# Product Bulletin

## VUM Improvement

### Blind Cap, Gauge, and Vent (Auto Drain Valve)

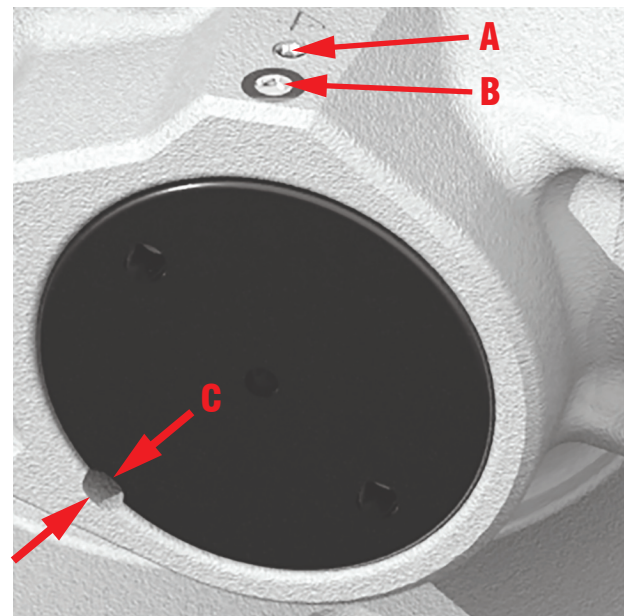
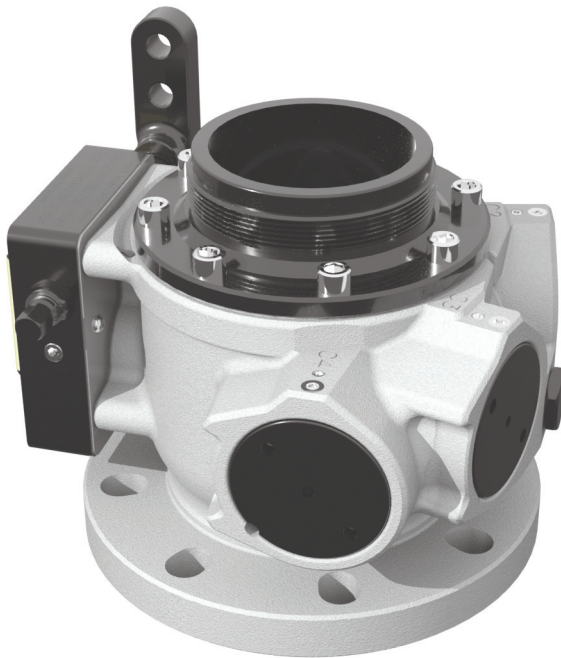
Features	Benefits
Reduced material	Lighter blind cap, gauge, and vent (auto drain valve)
Ball removal ports	Easier auxiliary port option re-configuration

Step 1 Remove 1/4"-28 set screw (location A).

Step 2 Loosen 3/8"-16 dog point set screw (location B) until the auxiliary port is able to swivel.

Step 3 Align ball removal port in auxiliary port option with ball removal port in VUM (location C).

Step 4 Remove 46 ball bearings from each auxiliary port. Rotate auxiliary port back and forth while applying air to (location A).

Step 5 Once all ball bearings are removed from auxiliary port, remove auxiliary port option from VUM.
